HISTORIC AND DESIGN REVIEW COMMISSION

March 03, 2021

HDRC CASE NO:	2021-057
ADDRESS:	1235 E CROCKETT ST
LEGAL DESCRIPTION:	NCB 1373 BLK 1 LOT S 125 FT OF 27
ZONING:	RM-4, H
CITY COUNCIL DIST.:	2
DISTRICT:	Dignowity Hill Historic District
APPLICANT:	Kali Tripp/Tripp Flip, LLC
OWNER:	Kali Tripp/Tripp Flip, LLC
TYPE OF WORK:	Removal of an existing front door
APPLICATION RECEIVED:	January 27, 2021
60-DAY REVIEW:	Not applicable due to City Council Emergency Orders
CASE MANAGER:	Edward Hall

REQUEST:

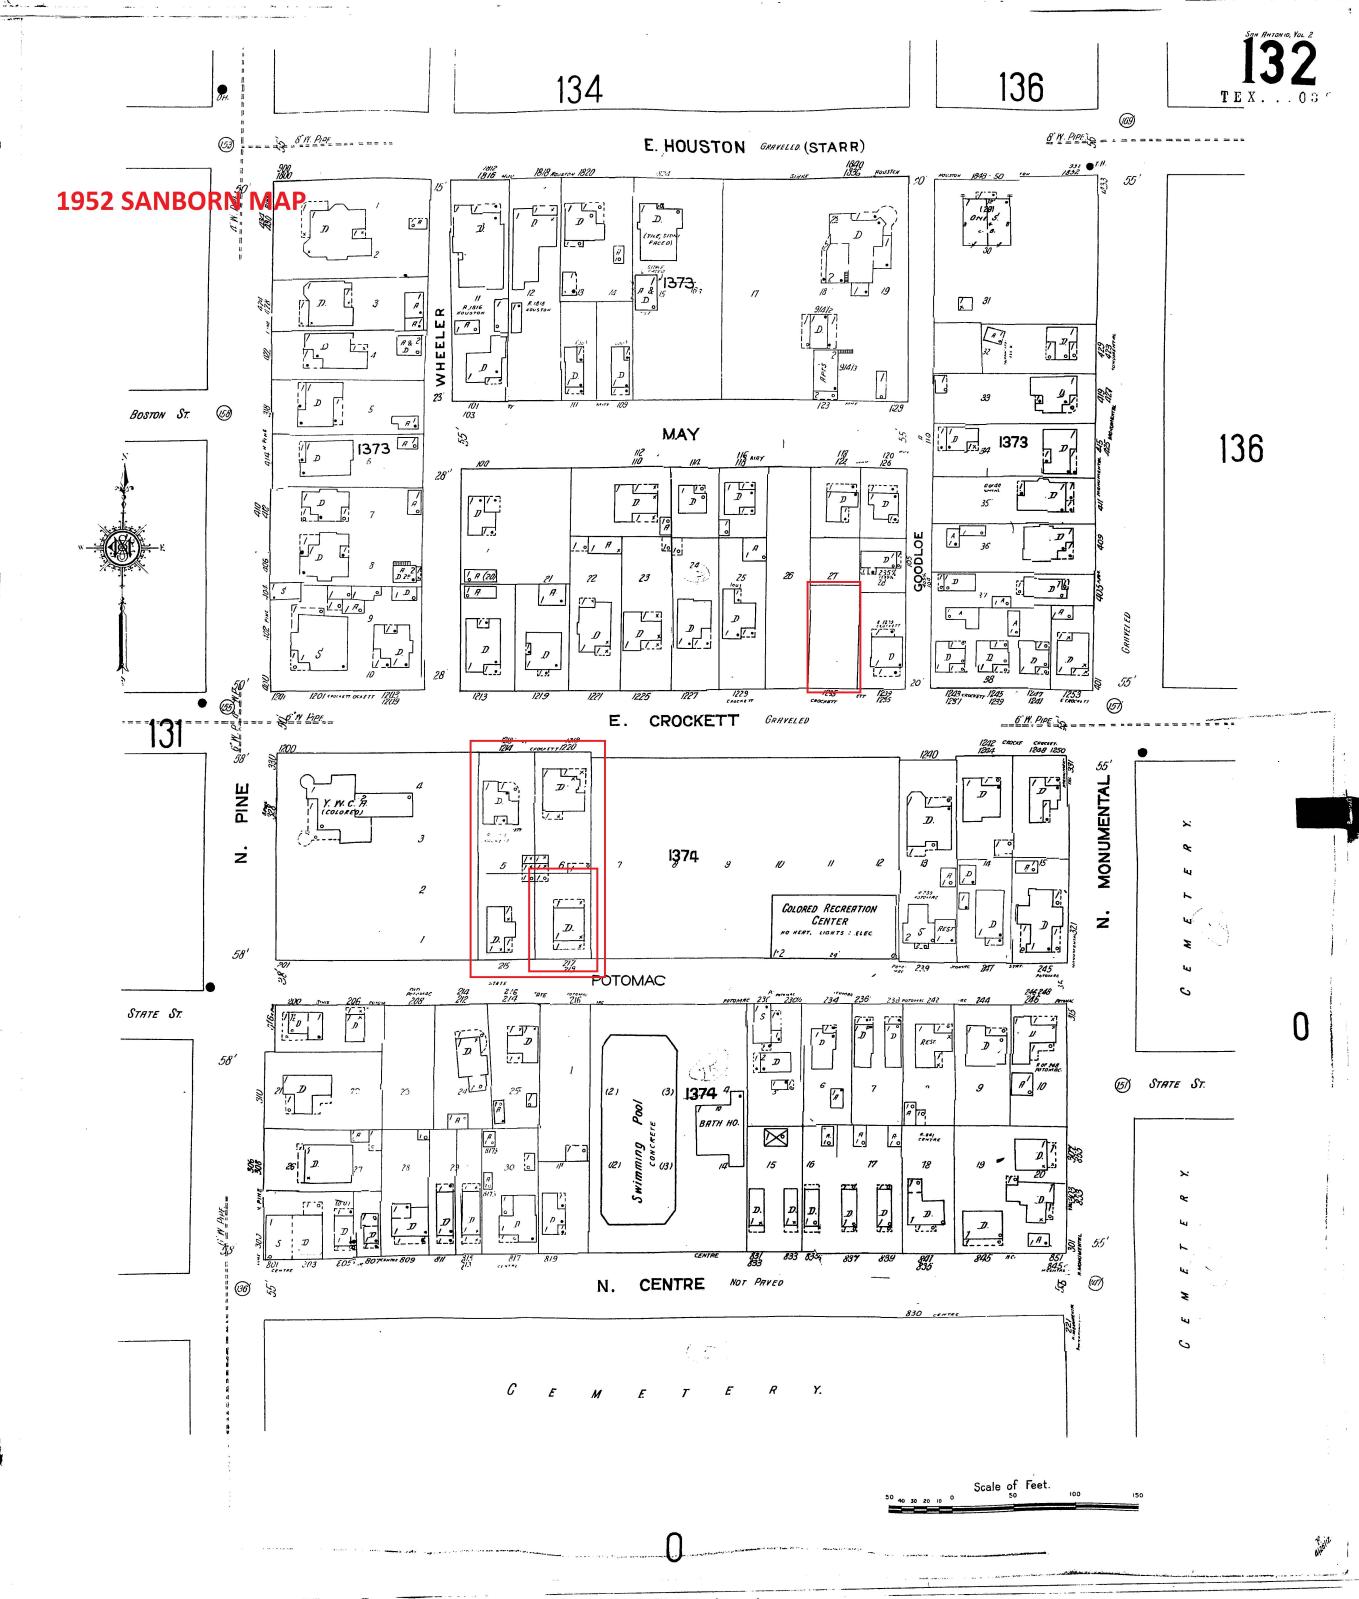
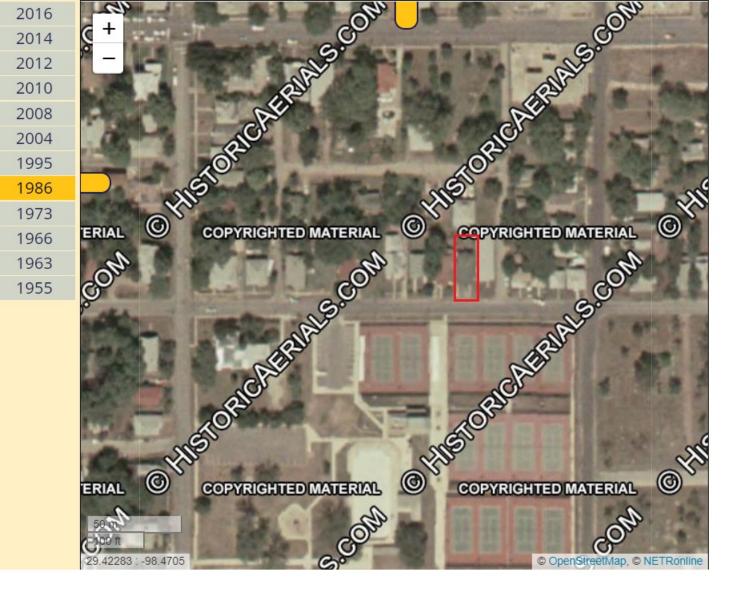
1. Remove second (east) front door

After demolition of interior of property, it was discovered that the original home was in fact a single-family home.

- Two doorways leading from the separate "units", or sides, of the home are in the original framing.

- The second door is not original to the home's framing, but was cut in at a later time.
